February 11, 2013

SAFETY RECALL NOTICE — SAYFLINK SLEEVE **Immediate Action Required**

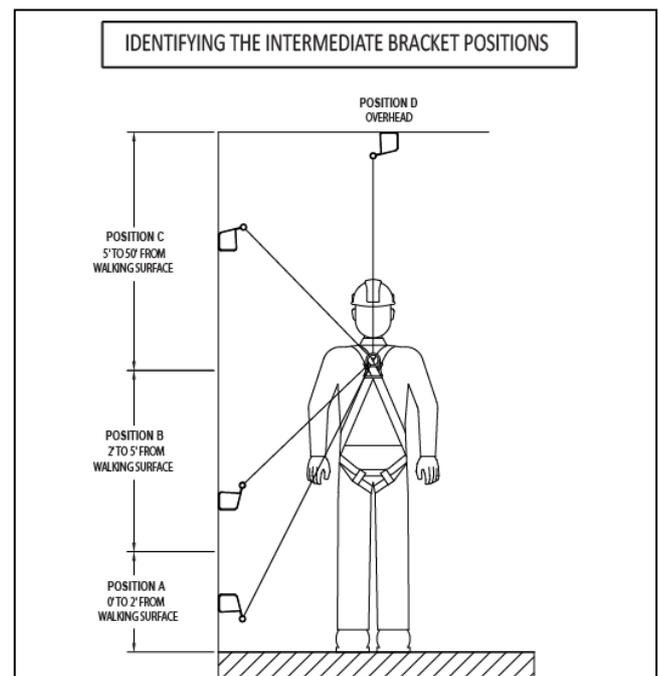
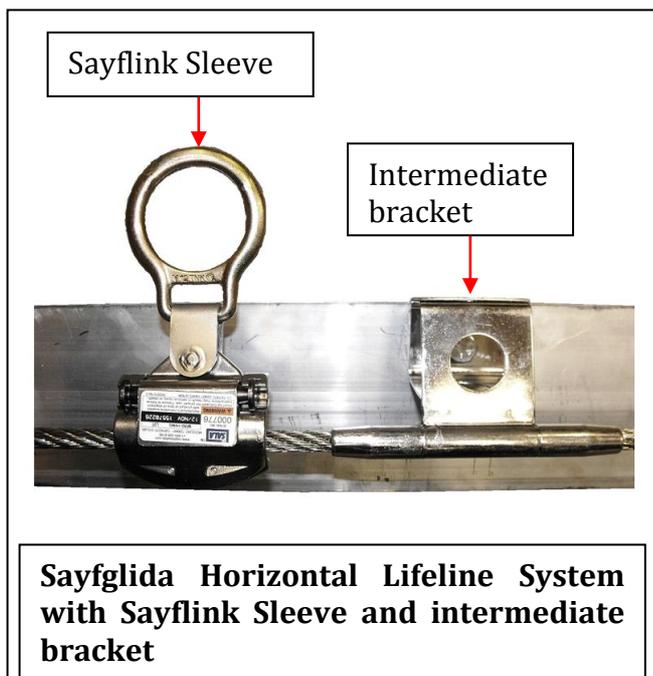
The reason for the recall is that, when the intermediate brackets are installed at walking surface level (between zero and two feet above the walking surface as illustrated in Position A below), there is a remote possibility that the sleeve can disengage from the cable as it slides over an intermediate bracket while trailing a worker moving across the walking surface. See "Identifying the Intermediate Bracket Positions" below.

Although Capital Safety's testing shows the Sayflink Sleeve is safe to use in bracket positions B, C and D as illustrated above (and any height between these positions), out of an abundance of caution, Capital Safety is recalling all Sayflink Sleeves regardless of the height of the permanently installed brackets.

If you have Sayflink Sleeves in service that were manufactured after May 2004, you should immediately take the sleeves out of service and call our Customer Service department at +33 (0)497100010 to arrange to return the sleeve. Capital Safety will repair or replace the sleeve dependent upon the specific needs of the end user. This will be done at Capital Safety's expense. The free replacement applies only if the returned sleeve is in proper working condition as determined by Capital Safety; if not, charges may apply.

Alternative fall protection must be used pending receipt of the upgraded sleeve. We recommend twin-leg lanyards to maintain 100% tie-off during use of the Sayfglida System.
